## PRODUCT CHANGE NOTIFICATION (PCN)

### AMJG0808-0050-GYB-26 MODULAR CABLE

CHANGE NOTIFICATION:	PCN 20220425_AMJG0808-0050-GYB-26
DESCRIPTION OF CHANGES:	CHANGE OF DATA SHEET CHANGE OF DATA SHEET New Draw.-No. ASS_7947_CArev02
REASON FOR CHANGE:	CHANGE OF PRODUCT LOCATION CHANGE OF PRODUCT LOCATION
KEY CHARACTERISTICS OF CHANGE:	Details see page 3
PRODUCTS AFFECTED:	AMJG0808-0050-GYB-26
DATE OF CHANGE AND IMPLEMENTATION:	CHANGE: WEEK 18 / YEAR 2022 IMPLEMENTATION: 25/4/2022
RESPONSE:	NO RESPONSE TO THIS NOTIFICATION IS REQUIRED

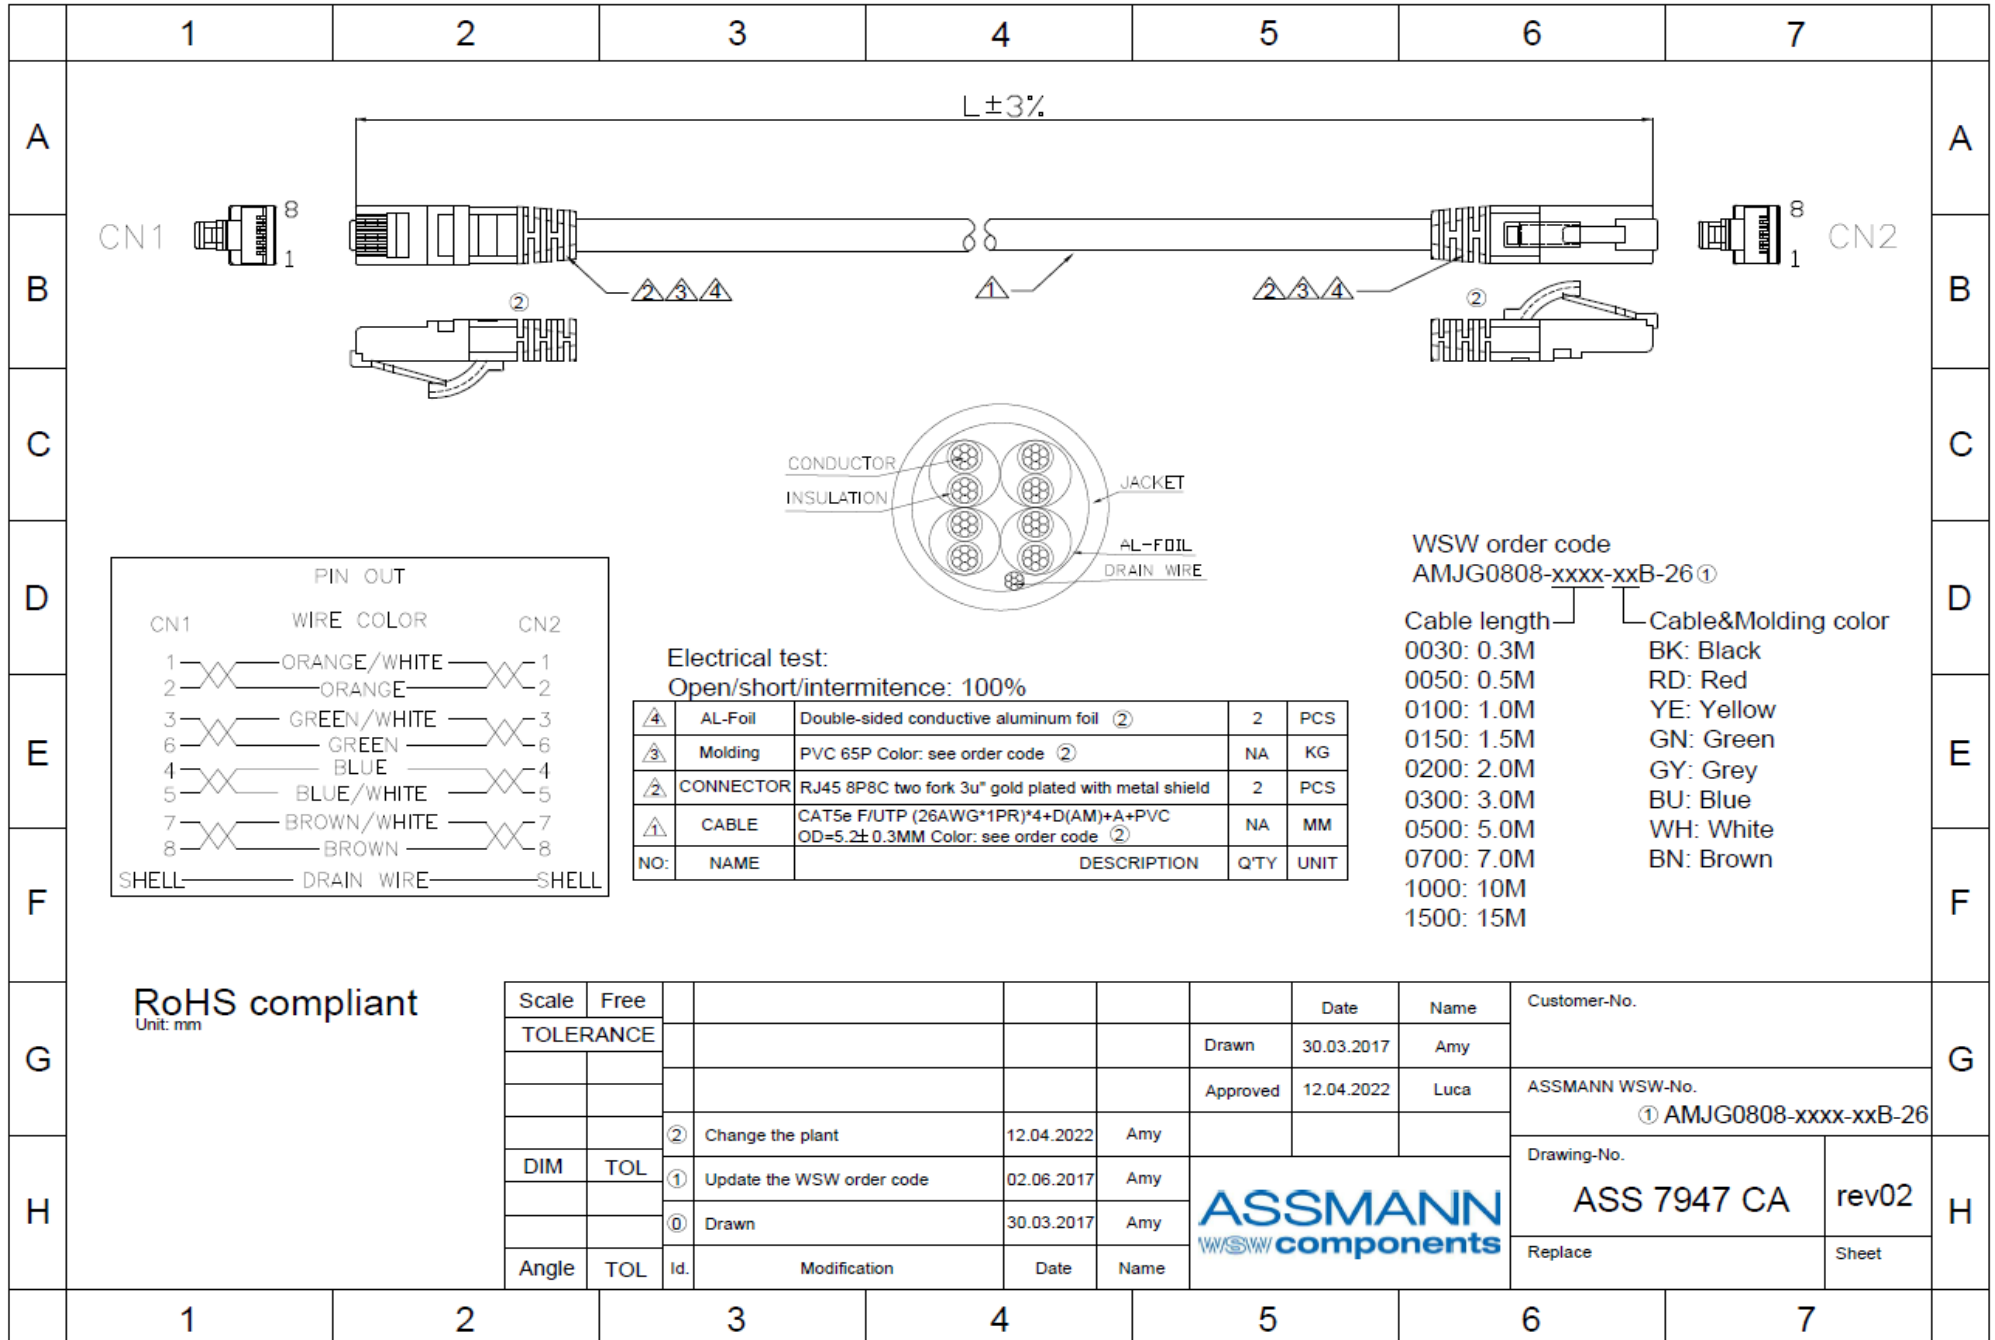
AMJG0808-0050-GYB-26	OLD VERSION	AMJG0808-0050-GYB-26	NEW VERSION																																													
<p>Appearance</p>		<p>Appearance</p>																																														
<p>BOM</p> <table border="1"> <thead> <tr> <th>NO:</th> <th>NAME</th> <th>DESCRIPTION</th> <th>Q'TY</th> <th>UNIT</th> </tr> </thead> <tbody> <tr> <td>③</td> <td>Molding</td> <td>PVC 45P Color: see order code</td> <td>NA</td> <td>KG</td> </tr> <tr> <td>②</td> <td>CONNECTOR</td> <td>RJ45 8P8C two fork 3u" gold plated with metal shield</td> <td>2</td> <td>PCS</td> </tr> <tr> <td>①</td> <td>CABLE</td> <td>CAT5e FTP (26AWG*1PR)*4+D+A+PVC OD=5,2±0,3MM Color: see order code</td> <td>NA</td> <td>MM</td> </tr> </tbody> </table>		NO:	NAME	DESCRIPTION	Q'TY	UNIT	③	Molding	PVC 45P Color: see order code	NA	KG	②	CONNECTOR	RJ45 8P8C two fork 3u" gold plated with metal shield	2	PCS	①	CABLE	CAT5e FTP (26AWG*1PR)*4+D+A+PVC OD=5,2±0,3MM Color: see order code	NA	MM	<p>BOM</p> <table border="1"> <thead> <tr> <th>NO:</th> <th>NAME</th> <th>DESCRIPTION</th> <th>Q'TY</th> <th>UNIT</th> </tr> </thead> <tbody> <tr> <td>⚠</td> <td>AL-Foil</td> <td>Double-sided conductive aluminum foil ②</td> <td>2</td> <td>PCS</td> </tr> <tr> <td>⚠</td> <td>Molding</td> <td>PVC 65P Color: see order code ②</td> <td>NA</td> <td>KG</td> </tr> <tr> <td>⚠</td> <td>CONNECTOR</td> <td>RJ45 8P8C two fork 3u" gold plated with metal shield</td> <td>2</td> <td>PCS</td> </tr> <tr> <td>⚠</td> <td>CABLE</td> <td>CAT5e F/UTP (26AWG*1PR)*4+D(AM)+A+PVC OD=5,2±0,3MM Color: see order code ②</td> <td>NA</td> <td>MM</td> </tr> </tbody> </table>		NO:	NAME	DESCRIPTION	Q'TY	UNIT	⚠	AL-Foil	Double-sided conductive aluminum foil ②	2	PCS	⚠	Molding	PVC 65P Color: see order code ②	NA	KG	⚠	CONNECTOR	RJ45 8P8C two fork 3u" gold plated with metal shield	2	PCS	⚠	CABLE	CAT5e F/UTP (26AWG*1PR)*4+D(AM)+A+PVC OD=5,2±0,3MM Color: see order code ②	NA	MM

NO:	NAME	DESCRIPTION	Q'TY	UNIT																																												
③	Molding	PVC 45P Color: see order code	NA	KG																																												
②	CONNECTOR	RJ45 8P8C two fork 3u" gold plated with metal shield	2	PCS																																												
①	CABLE	CAT5e FTP (26AWG*1PR)*4+D+A+PVC OD=5,2±0,3MM Color: see order code	NA	MM																																												
NO:	NAME	DESCRIPTION	Q'TY	UNIT																																												
⚠	AL-Foil	Double-sided conductive aluminum foil ②	2	PCS																																												
⚠	Molding	PVC 65P Color: see order code ②	NA	KG																																												
⚠	CONNECTOR	RJ45 8P8C two fork 3u" gold plated with metal shield	2	PCS																																												
⚠	CABLE	CAT5e F/UTP (26AWG*1PR)*4+D(AM)+A+PVC OD=5,2±0,3MM Color: see order code ②	NA	MM
